ECE/TRANS/WP.29/GRRF/2010/10/Corr.1  
10 December 2009

REGULATIONS Nos. 13 AND 13-H  
(Braking)

Emergency Stop Signal

Corrigendum

Natural engine brake, M<sub>1</sub> diesel vehicle, 1-5 gear

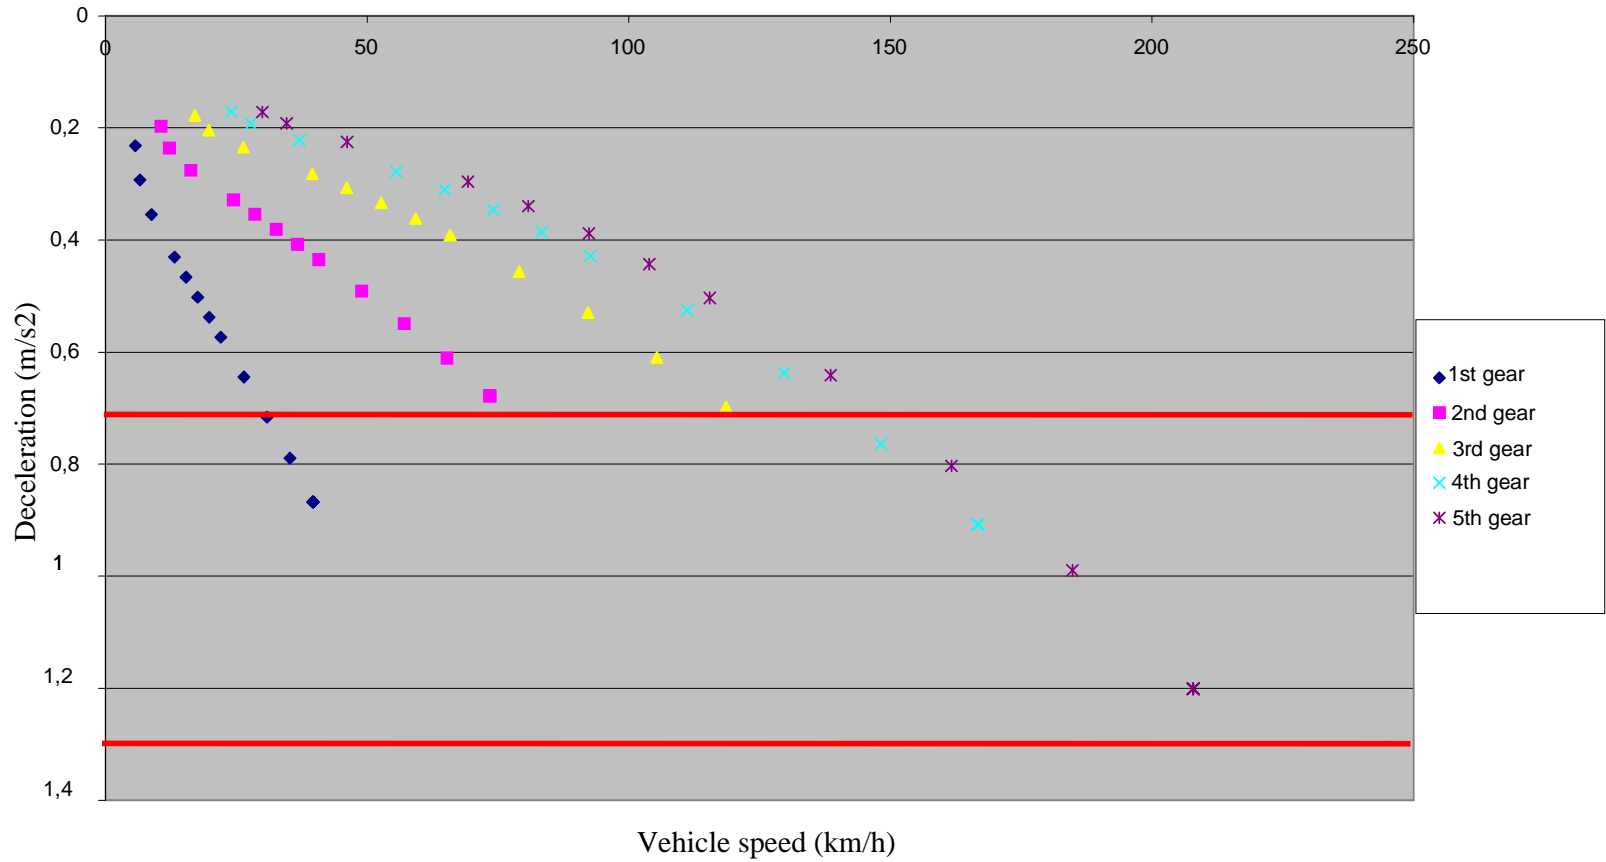
Page 5

For the existing graph substitute (see the graph next page):
